SINGAPORE CIVIL DEFENCE FORCE

Our Ref: CD/FSSD/12/02/03/01

AMENDMENTS TO FIRE CODE 2018 - 6th BATCH OF AMENDMENTS

Diagram 4.2.2i.(2) : Marking of fire engine accessway/fire engine access road

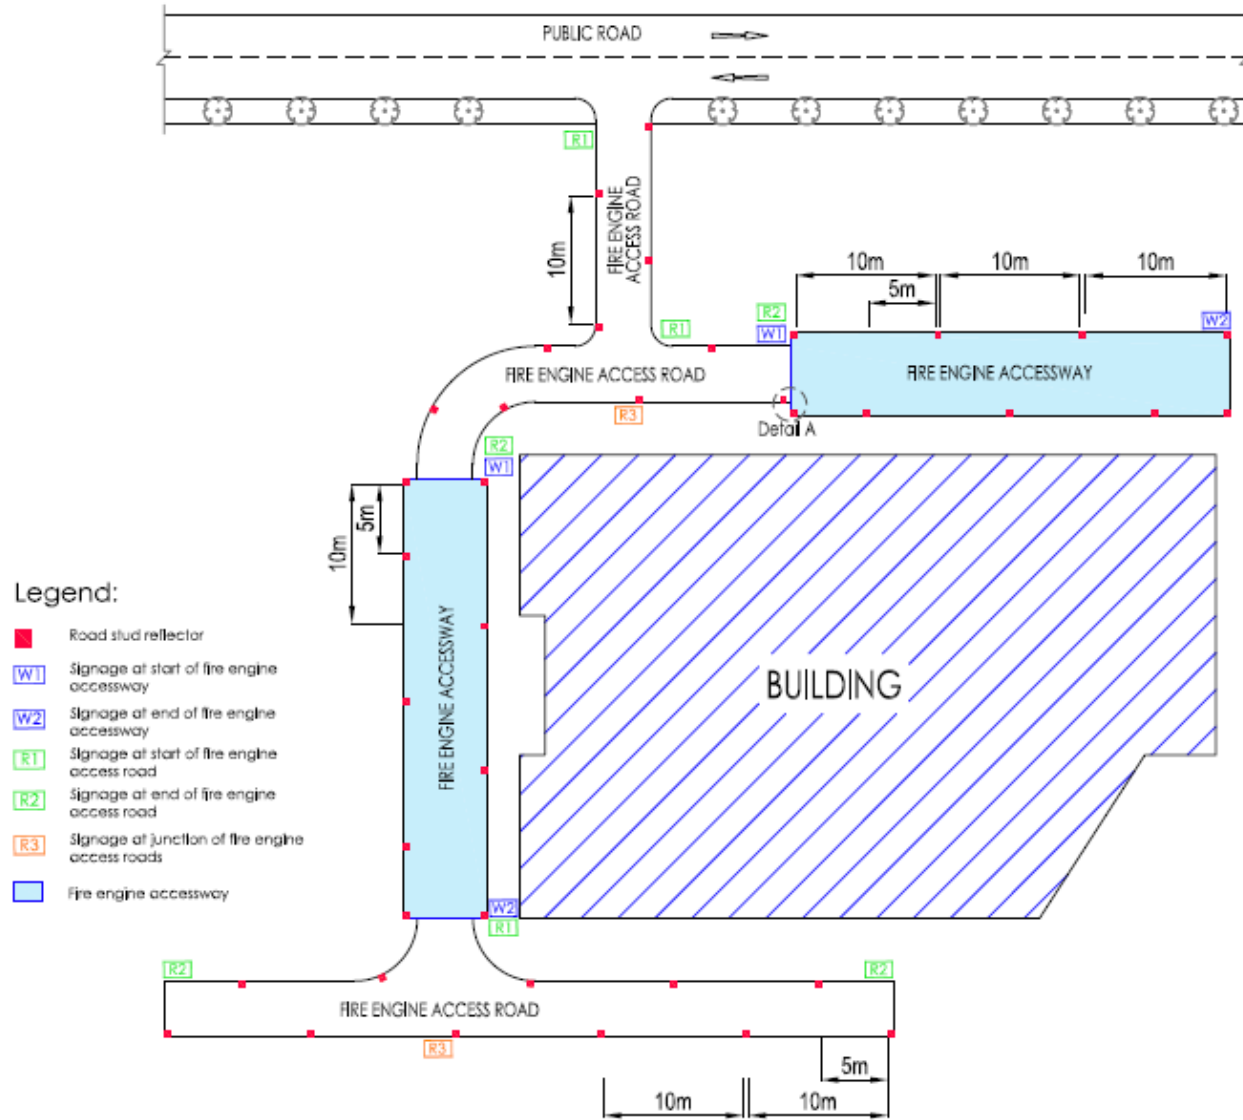
15	4.2.2i.	15 Sep 2020	15 Mar 2021	Revised	<p>Marking of fire engine accessway and fire engine access road</p> <p>(1) All corners of fire engine accessway/fire engine access road shall be marked, except where public roads are designated as fire engine accessway/fire engine access road.</p> <p>(2) Metalled/non-metalled or paved/non-paved surface fire engine accessways/fire engine access roads shall be marked with reflective white or yellow strips of size not less than 100mm (W) x 400mm (L). The markings shall be visible at night and shall be provided on both sides of the fire engine accessways/fire engine access roads at an interval of not more than 5m.</p> <p>(3) A sign post with white background and red wording of not less than 50mm in height shall be provided at the start and end of a fire engine accessway/fire engine access road. The height measured from the ground to the lowest point of the sign shall be</p>	<p>Marking of fire engine accessway and fire engine access road</p> <p>(1) All corners—of fire engine accessway/fire engine access road shall be marked, except where public roads are designated as fire engine accessway/fire engine access road.</p> <p>(2) Metalled/non-metalled or paved/non-paved surface fire engine accessways/fire engine access roads shall be marked with reflective white or yellow strips of size not less than 100mm (W) x 400mm (L), or white or yellow road stud reflectors of size not less than 100mm (W) x 100mm (L) x 18mm (H). The markings or reflectors shall be visible at all times night and shall be provided on both sides of the fire engine accessways/fire engine access roads at an alternate interval of not more than 5m. Markings or reflectors shall also mark all corners and turning corners of the fire engine accessway. See Diagram 4.2.2i.(2).</p>

Diagram 4.2.2i.(3) : Pictogram signage for fire engine accessway/fire engine access road

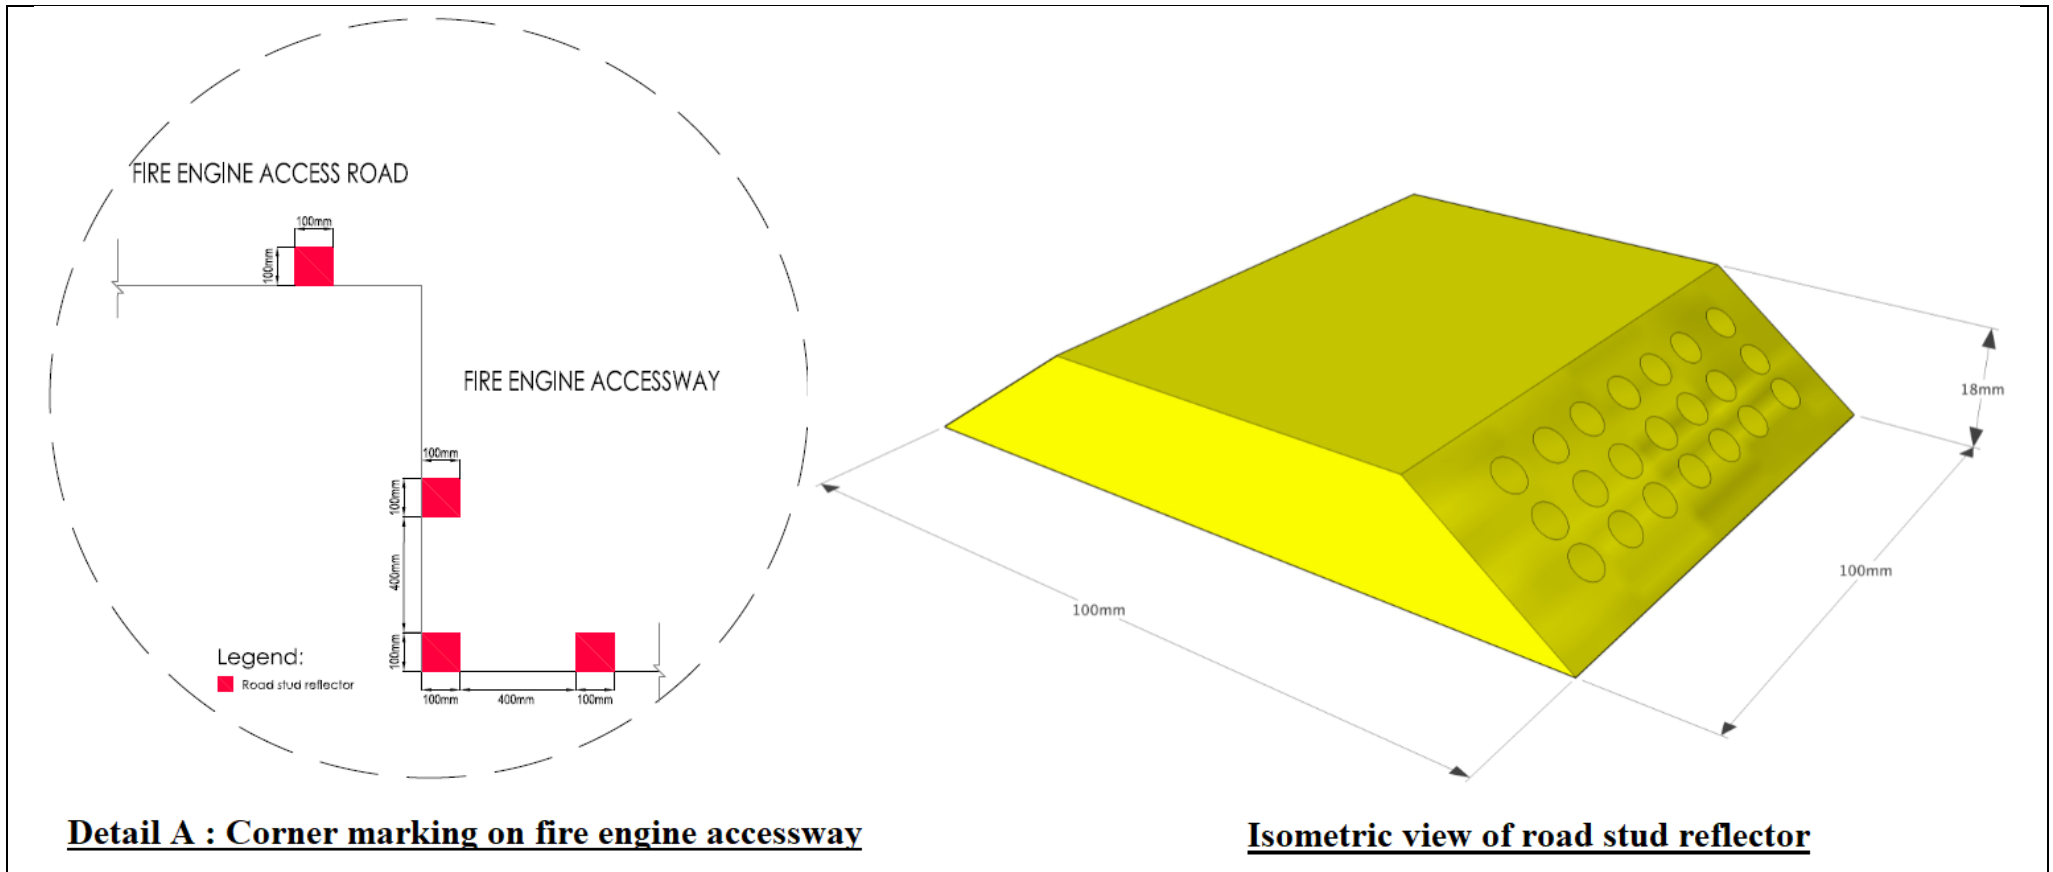
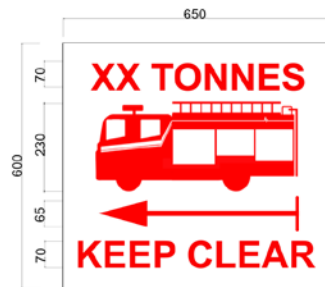
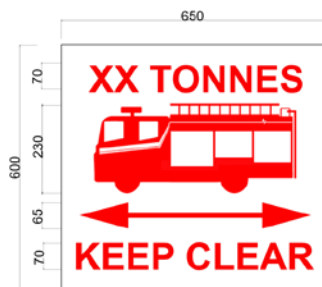
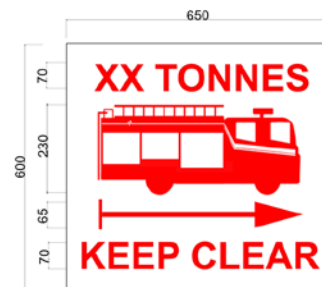
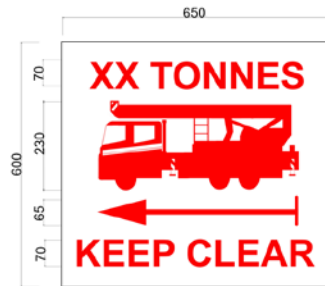
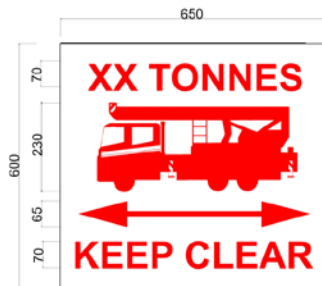
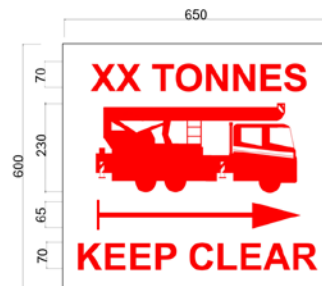
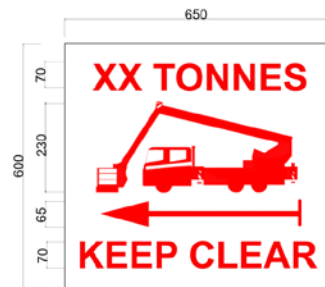
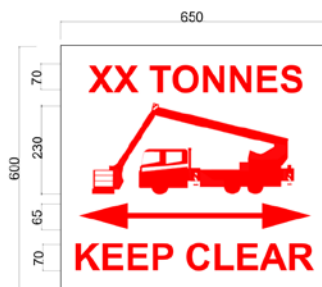
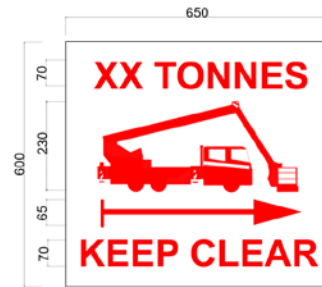
<p>between 2m and 2.2m. The sign post shall be visible at night and shall not be positioned more than 3m from the fire engine accessway/fire engine access road. Every part of the fire engine accessway/fire engine access road shall not be more than 15m from the nearest sign post. See <i>Diagram 4.2.2i.(3)</i>.</p>	<p>(3) A sign post with white background and red pictogram with upper case wording of not less than 50mm70mm in height shall be provided at the start, junction, and end of a fire engine accessway/fire engine access road. The height measured from the ground to the lowest point of the sign shall be between 2m and 2.2m 2.3m and 2.4m. The sign post shall be reflective, visible and unobstructed at all times at night and shall not be positioned adjacent to more than 3m from the fire engine accessway/fire engine access road. Every part of the fire engine accessway/fire engine access road shall not be more than 15m from the nearest sign post. For locations where there are more than one of such signs, the signs can be placed on the same post. See <i>Diagram 4.2.2i.(3)</i>.</p>
